Departure Request from DMC14.34 Design Guidelines

Project / Development Name:
Rio Vista

PLANNING DEPARTURE REQUEST FROM DMC 14.34 DESIGN STANDARDS FOR ELIMINATING PLANTER STRIP AND CONSTRUCT A RETAINING WALL OVER 4 FEET IN HEIGHT FOR A PORTION OF 272ND Place SE

WALL HEIGHT AND PLANTER STRIP WIDTH DEPARTURE
RIO VISTA

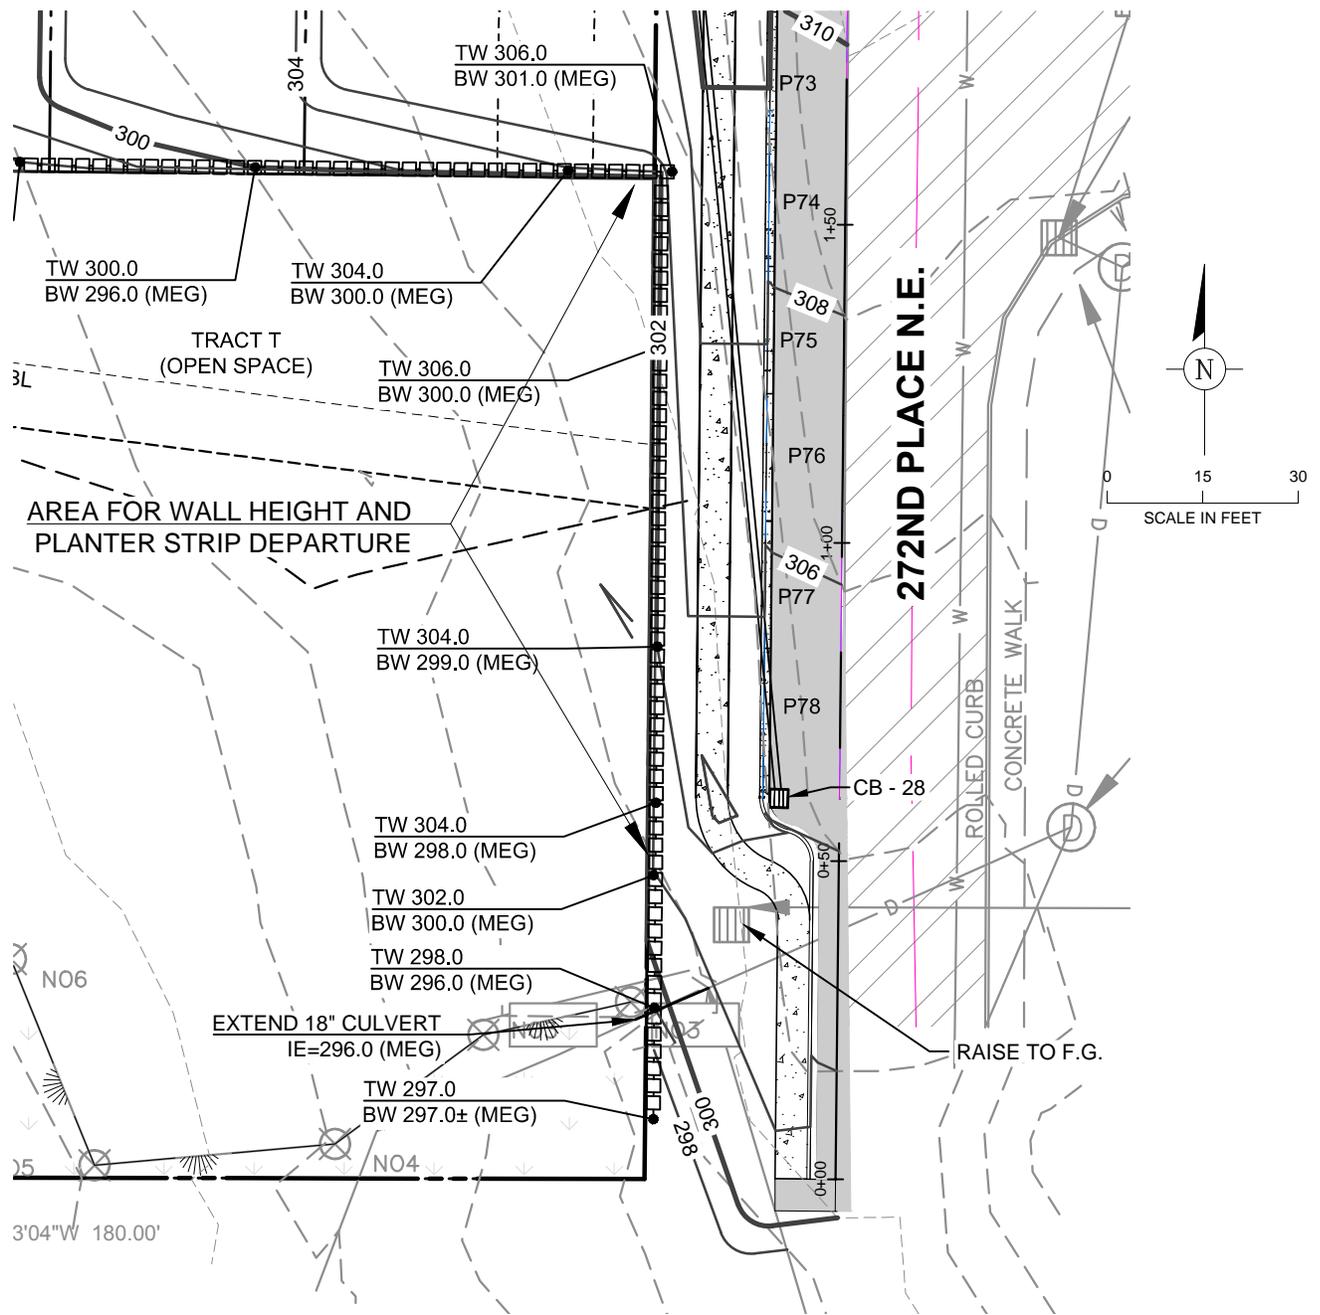
Applicant hereby requests a planning departure to a) construct a singular rockery retaining wall greater than 4 feet in height south of Lot #4 on the west side of 272nd Place SE and b) eliminate the landscaping strip per comment 43.c (as shown in the Departure Request). We request that the following response to the Planning Departure criteria be incorporated into the Departure Request justification.

A planning departure request is made to a) construct a retaining wall in excess of four (4) feet as a singular wall without setback along that portion of 272nd Place SE south of Lot #4 and b) to eliminate the planter strip along the 272nd Place SE right-of-way in this area.

The construction of retaining walls in excess of four (4) feet as a singular wall without setback is made in order to facilitate grading of the site to meet the minimum density required under the R-12 zone applicable to the Property. The area where this retaining wall is located is immediately adjacent to a wetland area and its buffer. Reducing the retaining wall to a singular wall in this location minimizes impact on the wetland and buffer area. The retaining wall is located downhill from the building lots and 272nd Place SE right-of-way; as such, there is no visual impact associated with the wall.

The elimination of the planting strip along this portion of 272nd Place SE is appropriate, because a) 272nd Place SE is a dead-end and will not be extended southerly by the Project; and b) The Project does not create any road, vehicular or pedestrian impacts southerly of Lot #4.

Criteria #1 is met due to the necessity to cluster buildable density on the Project because of extensive critical areas and their buffers.

Criteria #2 is met because an equal or superior design is achieved. To address any concerns regarding ensuring appropriate design and materials for the construction of said wall, Applicant is amenable to the City establishing a condition of preliminary subdivision approval requiring the design of the retaining walls to conform to the City's Design Standards (DMC 14.34) at final construction document approval.

Criteria #3 is met by using appropriate design and materials for construction of said wall to the planning director's satisfaction as a condition of construction plan approval.

Criteria #4 will be met by final review and approval of said retaining wall plans at final construction plan approval.
